COMMUNITY ROOTS  
HOUSING

DESIGN  
RECOMMENDATION  
SUBMITTAL

1323 EAST UNION STREET  
PROJECT # 3035728-LU

Community Roots Housing  
Administrative Design Recommendation RESPONSE  
1323 E. Union Street

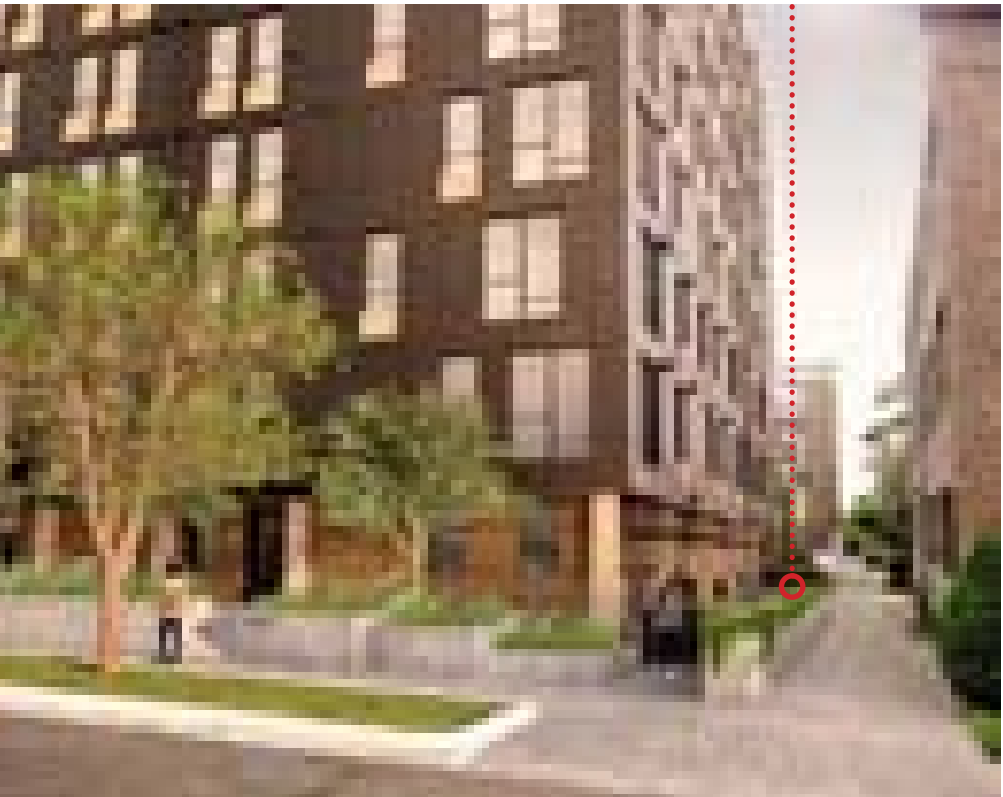
**2) 23.86.019: GREEN FACTOR MEASUREMENTS:**  
23.45.524 - LANDSCAPING STANDARDS – GREENFACTOR REQUIREMENTS  
SMC 23.45.524.A.2 REQUIRES LANDSCAPING IN MR ZONE TO ACHIEVE A MINIMUM GREENFACTOR SCORE OF 0.5. YET, PER 23.47A.016.A.2 A GREENFACTOR OF 0.3 IS REQUIRED IN NC ZONE. AS THIS PROJECT IS LOCATED ON THE BORDER BETWEEN NC AND MR ZONES **WE PROPOSE A TRANSITIONAL GREENFACTOR OF 0.4.**

**RATIONALE:**  
The site straddles a boundary between MR and NC zones and the predominant character of the neighborhood is consistent with NC zoning. The goal of the new building is to sustain and cultivate this character and help to unify the neighboring zones. Per CS3.1.a, the extension of existing positive attributes of the surrounding neighborhood character is encouraged.  
In keeping with the neighborhood NC character and to enhance street level interaction, (PL3.1.B) the design of the new building will provide a generous porch area coupled with exterior ground floor residential entrances (PL3.1.G) along Union St. and the west easement. This buffered semi-private walk will soften the existing easement and help integrate the building into a coherent neighborhood identity, softening the private easement and residential Texada building to the west.  
We would like to provide a balance of landscaping consistent with the values and feel of the area and would like to request the green factor requirement be adjusted to 0.4 in recognition of the transitional nature of this site.

Green walls are consistent with the character of the neighboring NC zoning, as well as the neighborhood as a whole. They also elevate the quality of the pedestrian environment.

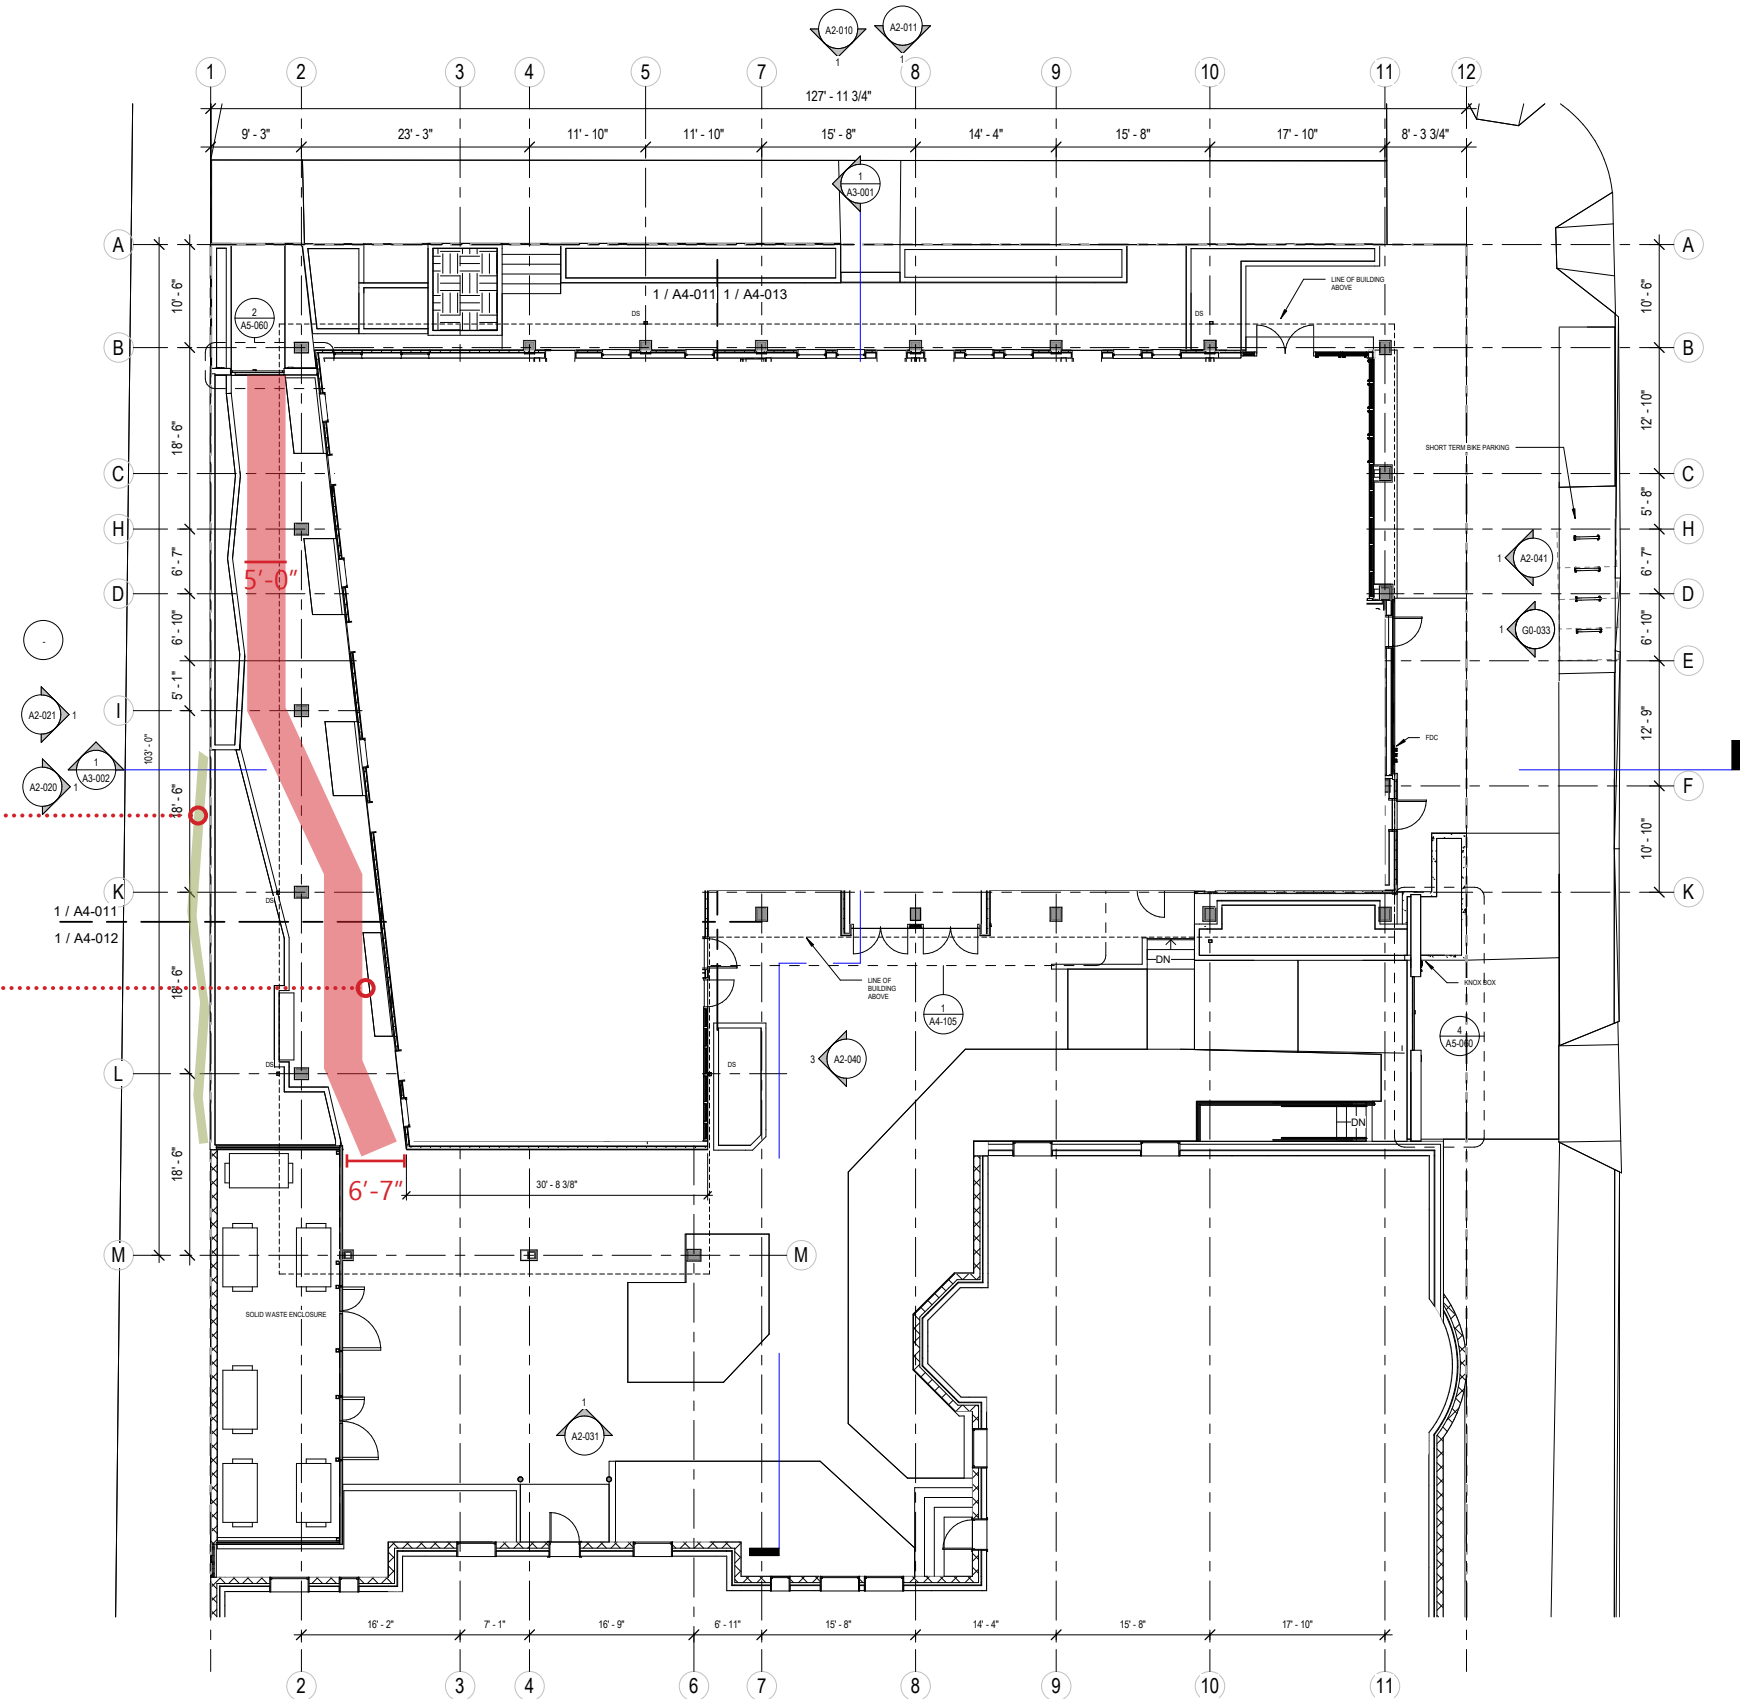
The entry from Union would be more inviting if the landscaping opened up into the courtyard. The current design feels pinched and closed off from the open space of the courtyard, and the main entry to Heartwood.

A 4' high gate, within a sheltered entry space, creates a safe space to find the key fob, to enter the gates, between the two planters off of the sidewalk on Union. Creating a secondary 'street' the pathway is a semi-private space for the west facing studio units; the planters screen the alley-like easement, and the plantings screen them further. On the alley-easement side, a vegetated green wall spills over the planter edge creating a west green wall, along the property boundary.

The southern most planters in the West corridor have been adjusted so that the path widens into the courtyard, while still maintaining some privacy to the West units. The bench placed at the Southern portion of the corridor extends the public elements of the courtyard into the Union entry threshold.

**WINDOW DEPTH**

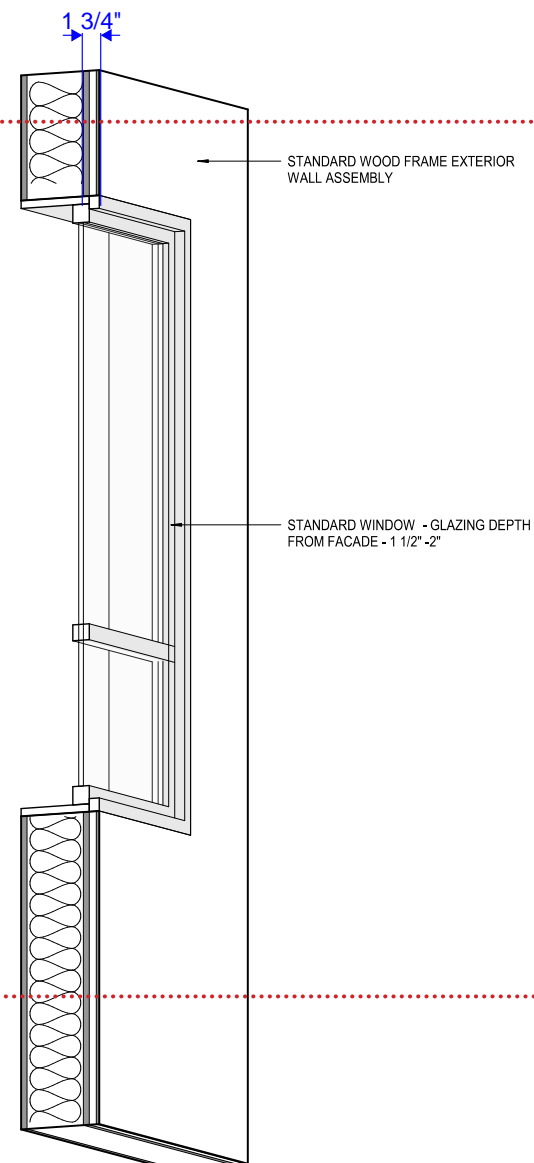
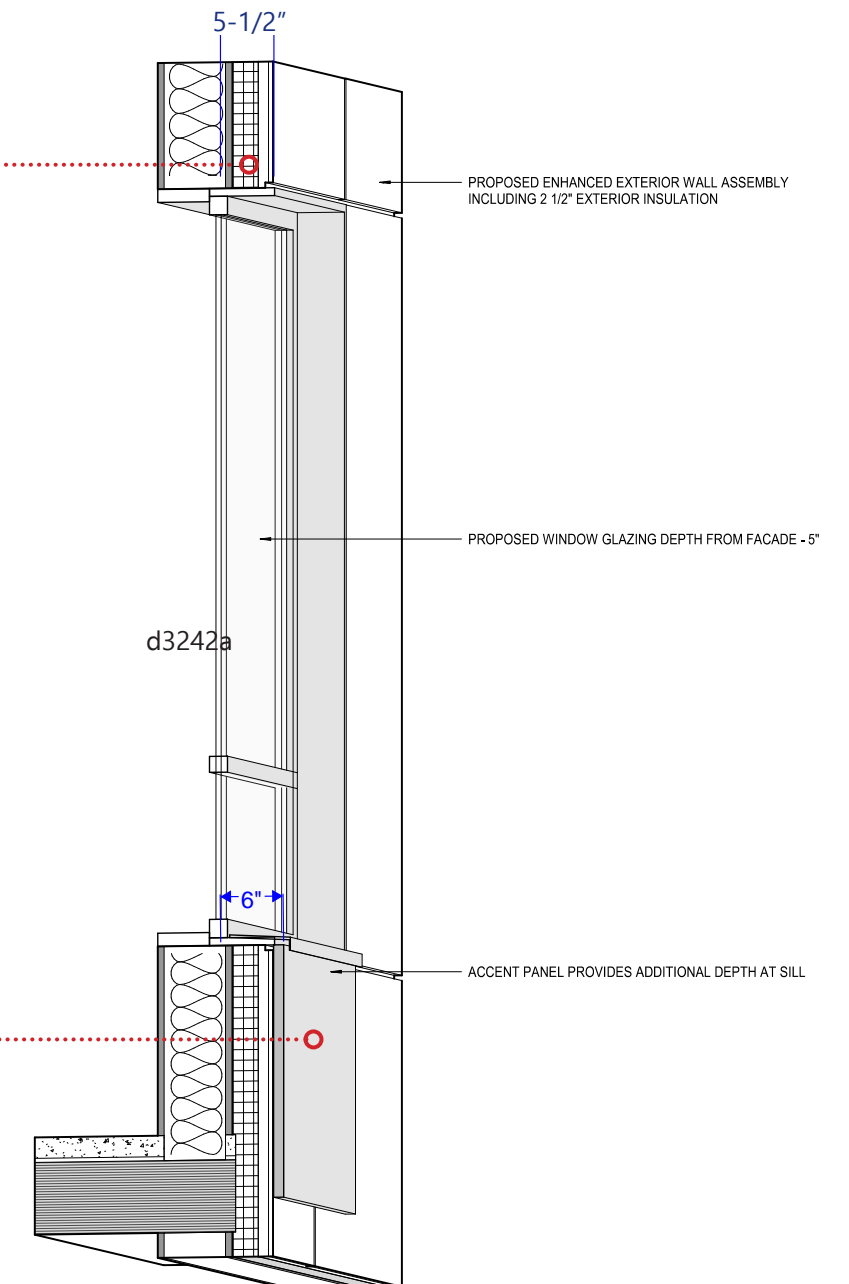
A deeper window sill would be preferred to provide visual depth to the building.

Windows will be placed 5-1/2" from the exterior wall finish material, which will provide shadow lines and texture to the elevations of the building.

The high energy performance of the building and the use of mass timber in the building helps to create a wall section with exterior insulation, on the outside of the metal stud exterior walls. Due to seismic constraints, mass timber was not able to be used as an exterior wall structure, but the use of mineral wool on the exterior of the stud walls provides superior insulation qualities to meet the stringent Built Green standards dictated by the MHA Performance option. Windows were set in on the metal stud walls, creating a window cavity that is up to 5.5 inches, far deeper than is typical for a building of this type. The rhythm of the building openings relative to building mass, creates a strong, timeless elegance that relates to the 19th and early 20th century brick buildings context that the project is surrounded by.

Adding the wood-toned accent sill, as the singular ornamental element on the facade, provides an additional depth, bringing the wall depth to a perceived 6". The repetitive use of the ornamental wall panel reminds the careful observer of the basic superstructure construction method - massive wooden panels. The panels are mounted on the outer face of the simple, modest dark, painted fiber-cement panels, in order to create a sense of depth, repetitive power and subtle modulation on the facade. They are a clue that the building is constructed out of mass timber panels - elements that are as of yet, out of the ordinary for a building of this type and scale.

CONVENTIONAL WOOD CONSTRUCTION  
(TYPE V A/B) WINDOW DETAIL: **NOT USED**

HEARTWOOD WALL ASSEMBLY AND WINDOW DETAIL:  
**PROPOSED**

MUP SUBMITTAL RENDERING  
UNION FACADE

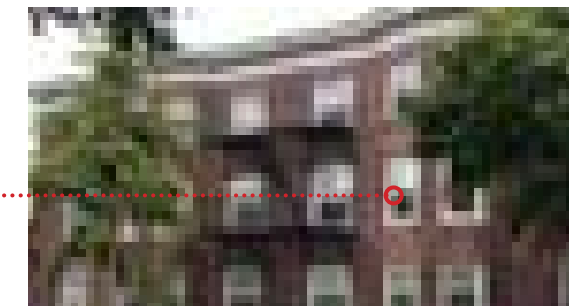
It has been recommended to consider the proportions of the window groupings of adjacent older buildings.

In looking at the two neighboring early 20th century brick building, the Texada on Union and the Helen V, two different use of window groupings were found. In the Texada, windows were grouped together in a horizontal band, while in the Helen V, the windows were more traditional 'punched' windows, standing individually. The project elected to work with the Helen V window typology, as the two buildings were on the same site, and shared the same entries and courtyard. However, during the evolution of the design between MUP Submittal and Design Recommendation Response the window patterning of the latter grouped the windows more closely together to account for careful interior placement of the windows in order to maximize light and views into the small studio units.

**FACADE PANEL PROPORTION ADJUSTMENT**

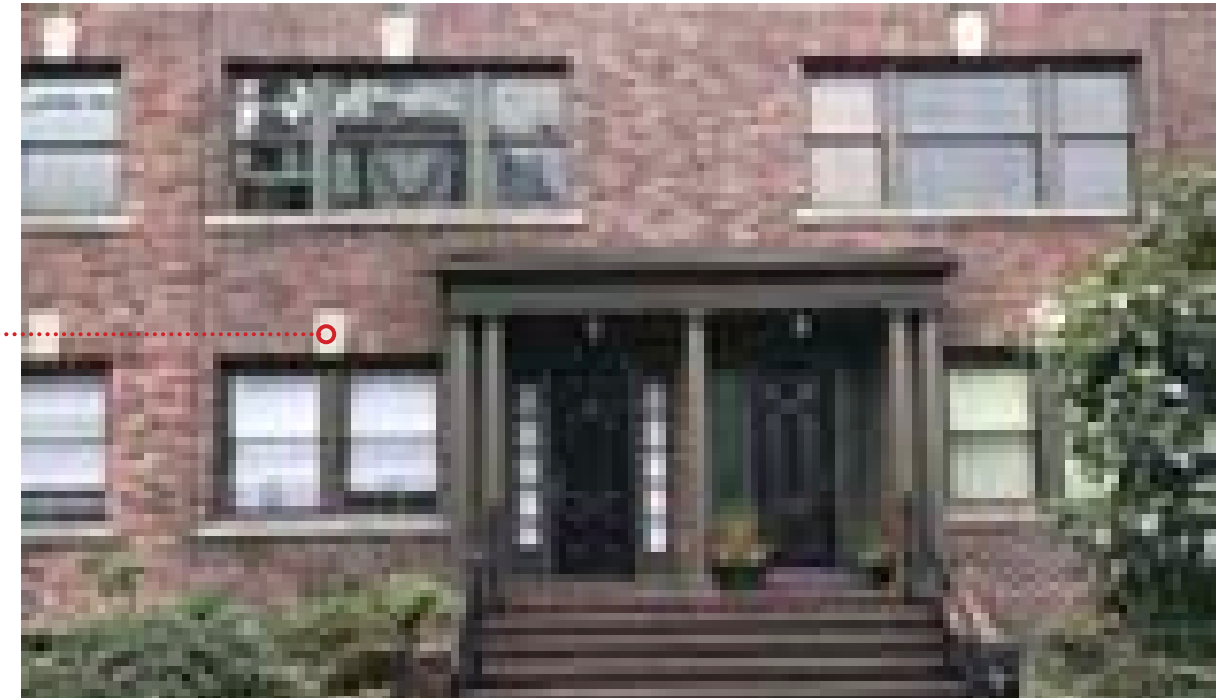
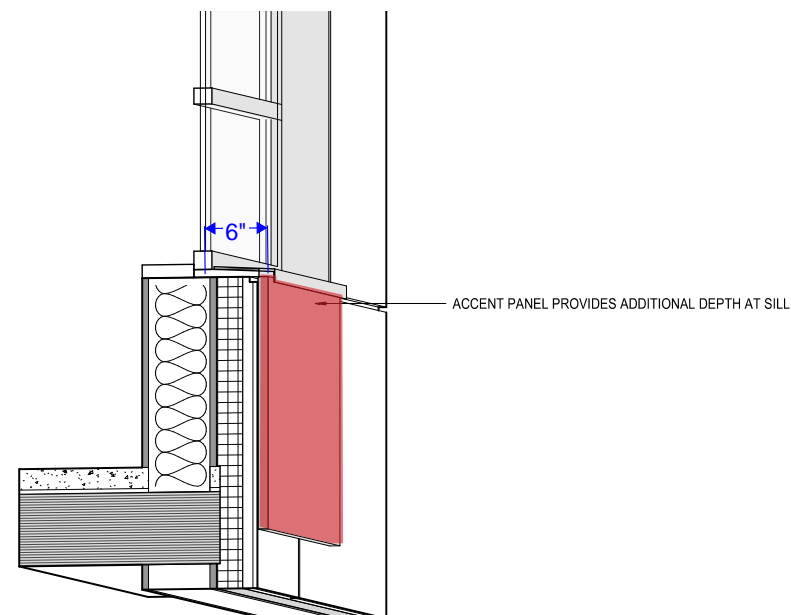
It has been recommended to adjust the wood toned panels at the windows to emulate the proportions of the window sills of the adjacent buildings.

The 24" wood-toned panels add to the elegant verticality of the building by visually extending the proportion of the windows. The wood toned panels conceptually act as a "keystone" element to the windows, referencing the neighboring keystones in the traditional brick buildings to the west of the building.

Like the mass timber panels used as the superstructure for the new building, the keystone was a constructive, tectonic element used to balance stereotomic forces of two brick elements meeting over an opening below. While these simple early 20th century brick buildings did not use the keystone in an constructive fashion, it is used here as an ornamental element. In the same way, the new building uses a wood-toned panel on the outside of the building as a clue to the interior, concealed super structure of the building.

The panel can also be seen as part of the window construction, a sill, however, in this case, the ornament element is much deeper than a traditional window sill, implying the generous, light-filled, spaces with open wood ceilings, and exposed wooden columns and beams within the building's units,.
